Title: 23XL PSIO INSTALLATION
INSTRUCTION

Number: C9605
Date: 1/25/96
Supersedes:
Date:

To provide a copy of the 23XL PSIO
installation instruction sheet number
99TA550150 Rev. A.

23XL PSIO INSTALLATION INSTRUCTIONS

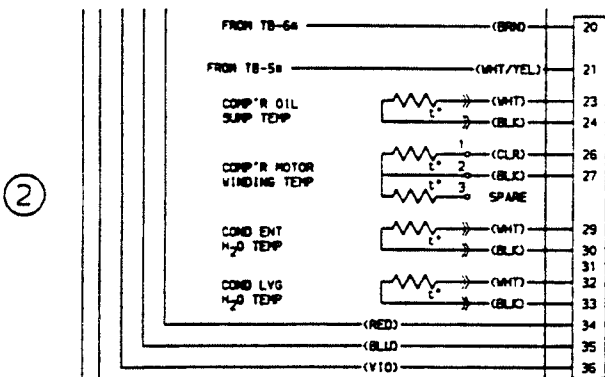
- a. Remove the yellow wire connecting terminal **50** to terminal **6**.
 - b. Locate the brown wire connected to terminal **1** and originating from the wire harness leading to the control panel (*not* the brown wire connecting terminal **1** to the oil heater contactor). Relocate that brown wire from terminal **1** to terminal **6**.

- c. Affix the provided power panel schematic adhesive label #1 (partial) to the matching location on the original label on the power panel door.
 4. In the control panel:

APPLIES ONLY TO POWER PANEL LABELS FOR UNITS WITH OIL LEVEL SAFETY SWITCH WIRED TO POWER PANEL TERMINALS 5 & 6 (EARLIER DESIGN) VIA A GRAY-SHEATHED CABLE.

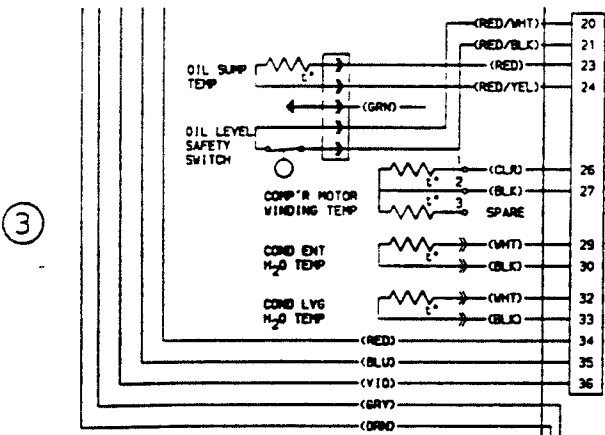
- c. Remove power to the power panel.
 - d. Install the new PSIO module (with Version 14 or later software).
 - e. Locate the white/yellow wire connected to plug **J7**, pin #19. Move this wire from pin #19 to pin #21 (within plug **J7**).

- f. Reconnect all plugs from the PSIO module.
 - g. Affix the provided control panel schematic adhesive label #2 (partial) to the matching location on the original label on the control panel door

- c. Remove power to the power panel
 - d. Install the new PSIO module. (with Version 14 or later software).
 - e. Disconnect the brown wire connected to plug J7, pin #20. Cut off the stripped lead end, tape or insulate and restrain wire to prevent grounding. (Wire is to be left disconnected.)

- f. Locate the red/white wire connected to plug J7, pin #19; move this wire from pin #19 to pin #20 (within plug J7).
 - g. Locate the red/black wire connected to breaker CB2. Disconnect from CB2, strip end, and insert into plug J7, pin #21.

- h. Reconnect all plugs from the PSIO module.
 - i. Affix the provided control panel schematic adhesive label #3 (partial) to the matching location on the original label on the control panel door.

APPLIES TO CONTROL PANEL LABELS FOR UNITS WITH OIL LEVEL SAFETY SWITCH WIRED TO POWER PANEL TERMINALS 5 & 6 (EARLIER DESIGN) VIA A GRAY-SHEATHED CABLE.

APPLIES TO CONTROL PANEL LABELS FOR UNITS WITH OIL LEVEL SAFETY SWITCH WIRED TO THE PS10 CONNECTOR IN THE CONTROL PANEL VIA A YELLOW-SHEATHED CABLE (LATER DESIGN).
